No. 54
PAGE TELEPRINTER

MAINTENANCE INSTRUCTIONS

(1st Edition — Issued November 1954)

AMENDMENTS TO BOOKLET NO. 54 (1st Edition)

FIG. 20

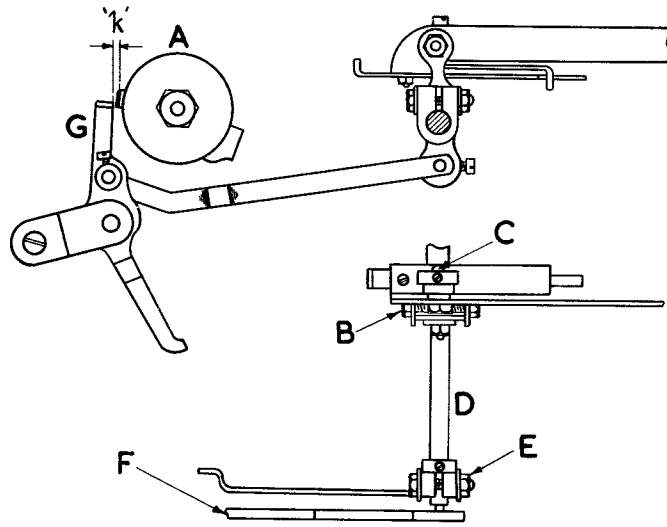
Delete dimension 'k' from Fig. 20 of Booklet No. 54.

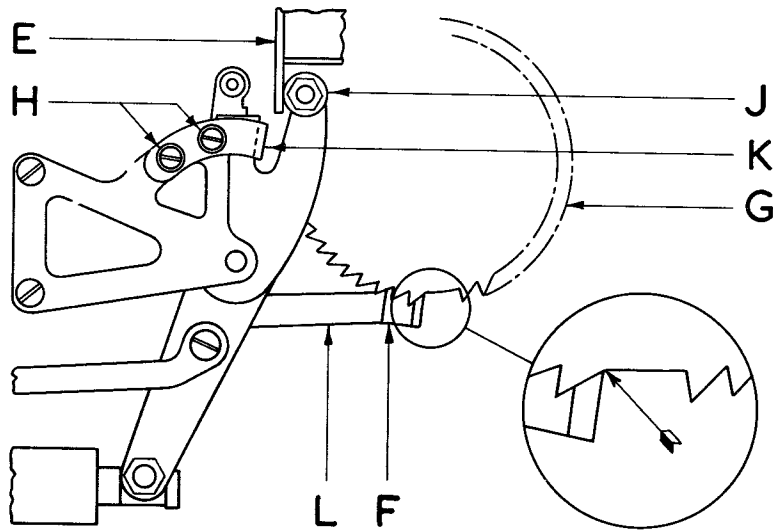
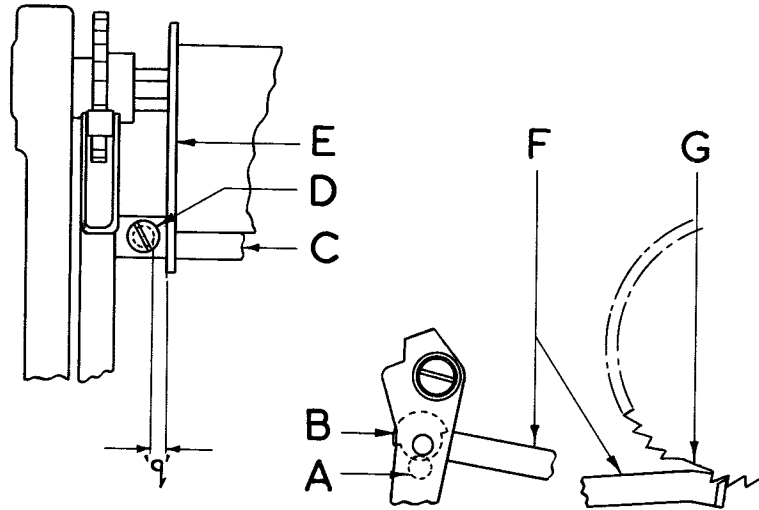
On pages 18 and 19, delete adjustments 43, 44 and 45, and insert the following new adjustments:-

43.1 Remove the unit from the machine. Slacken clamping screw A, Fig. 42, (on the back of the frame behind the letter feed levers), and clamping screw P, Fig. 44. Set the eccentrics B, Fig. 42, and N, Fig. 44, to their neutral positions, i.e. with their slots horizontal.

- (i) On Fig. 42, delete dimension 'q'.
- (ii) On Figs. 55 - 58, delete dimension 'c': "1/32 in. (.8 mm)" and insert ".020 - .040 in. (.51 - 1.02 mm.)".
- (iii) On Figs. 67 - 68, delete dimensions 'a', 'b' and 'c', and insert the following new dimensions:

FIG. 53

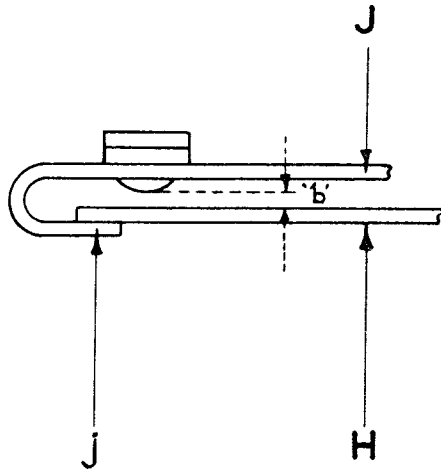
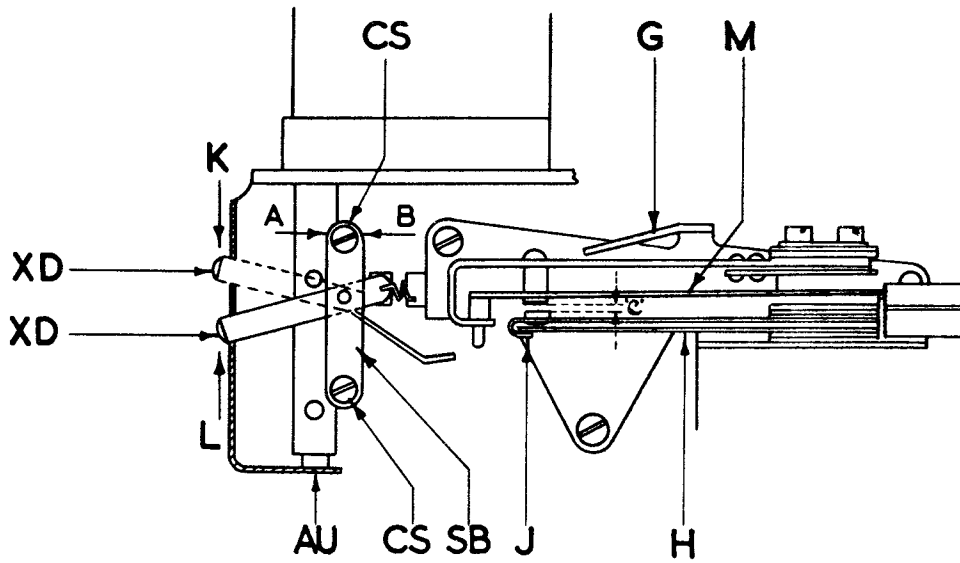
Figs. 53-54, dimension 'b', delete ".010 in. (.25 mm.)" and insert ".010 - .020 in. (.25 - .51 mm.)".

FIG. 55

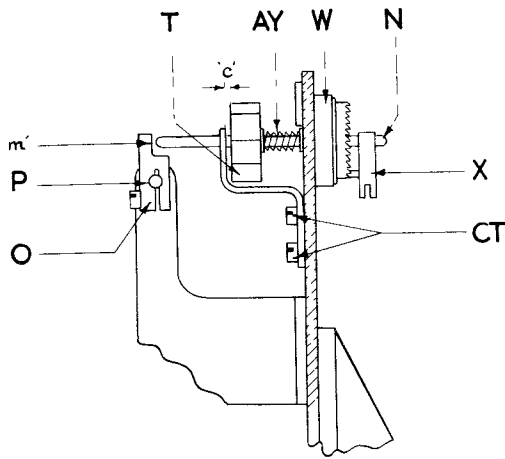
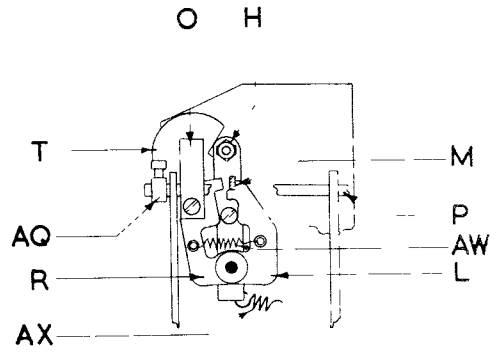
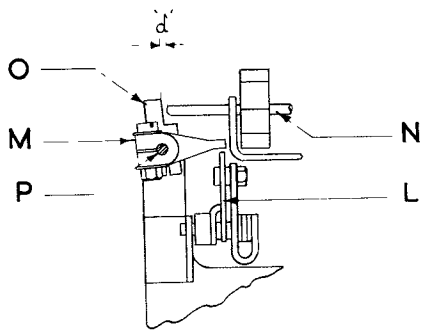
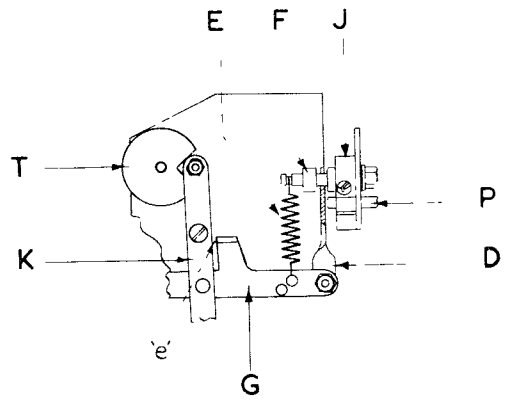
On page 22, adjustment 58.4, delete "1/32 in. (.8 mm)" and insert ".020 - .040 in. (.51 - 1.02 mm.)."
